# **TMS320UC5409/TMS320VC5409**

### **Silicon Errata**

*SPRZ156E*  
January 2000  
Revised October 2001

**Figure 3. DMA Memory Map Extended Program/Data Pages**

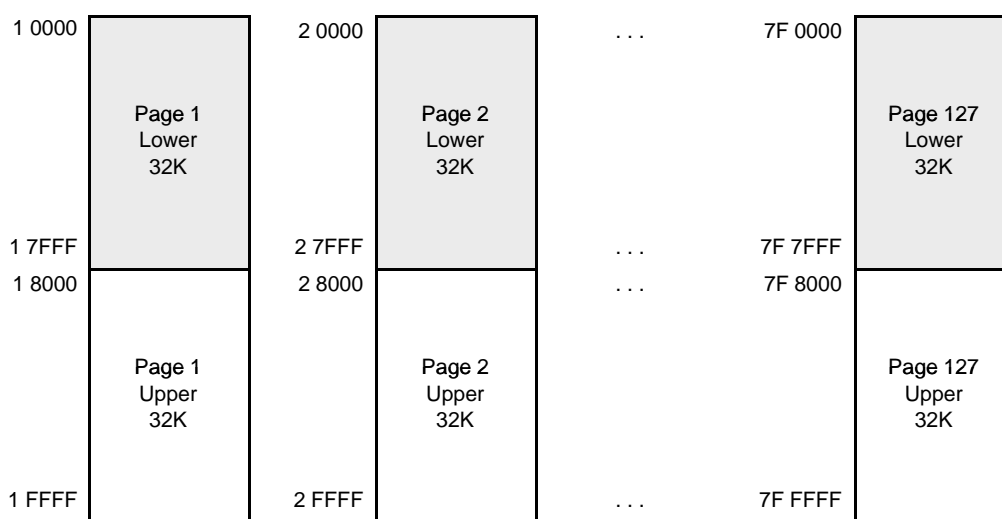
**Details:** The DMA on the 5409 can access up to 128 pages of data, I/O, and program memory. When DMA write accesses are performed on the lower 32K words of extended data or program pages 1 through 127 (areas shaded in grey in Figure 3), the writes affect both the external memory location on the selected page, and the internal memory location corresponding to the same 16-bit address of page 0.

**Workaround:** The lower 32K words of extended program and data pages 1 through 127 within the DMA memory map should be considered reserved and not used.

This problem is corrected in Revision A silicon.
